"Road equipment"
"Equipements de la route"
"Straßenausstattung"

**CEN/TC 226 – Draft Decision D 619c/2017
WG 10 – Adoption of a New Work Item (NWI) for the prEN 12767
"Passive safety of support structures for road equipment —
Requirements and test methods"**

Action : **Vote CIB – Deadline: 2017-03-20**

Figure D.1 — Vehicle dimensions

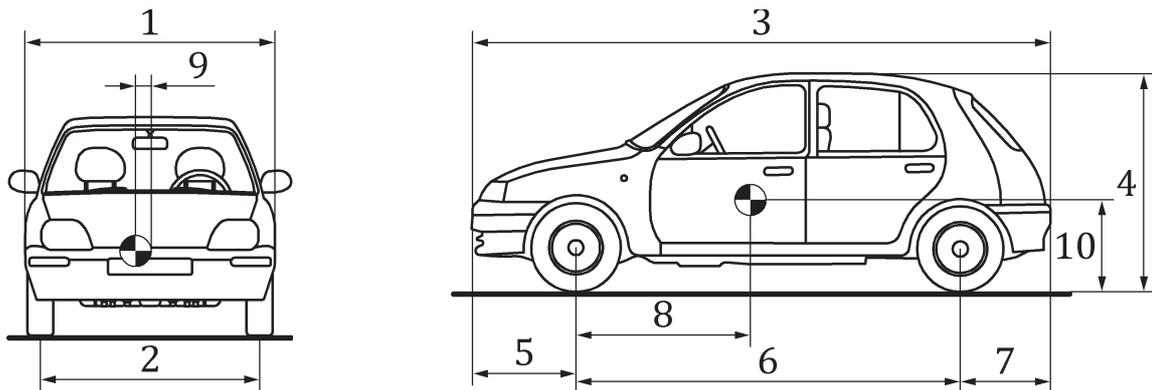
GB 307		D1	Figure D1	ed	<p>The vehicle in the Figure looks outdated</p>	Update the vehicle in the Figure	<p>RETAINED</p>
CH 308		E.1		te	<p>The calibration test shall be performed with a test vehicle impacting a vertical, rigid cylinder head-on with the vehicle centre-line aligned with the centre-line of the cylinder.</p> <p>The cylinder shall have a diameter of 260 mm ± 20 mm and a height greater than the contact surface of the deformed car front, typically greater than 1 m.</p> <p>At the moment of impact the lateral offset of the two centre-lines shall not exceed 100 mm. The test shall be conducted at (35 ± 2) km/h, and the rigid cylinder shall not displace statically more than 10 mm during the test, measured at the contact surface.</p>	<p>A precise and clear formulation is needed</p>	<p>NOT RETAINED</p> <p>Clear enough</p>
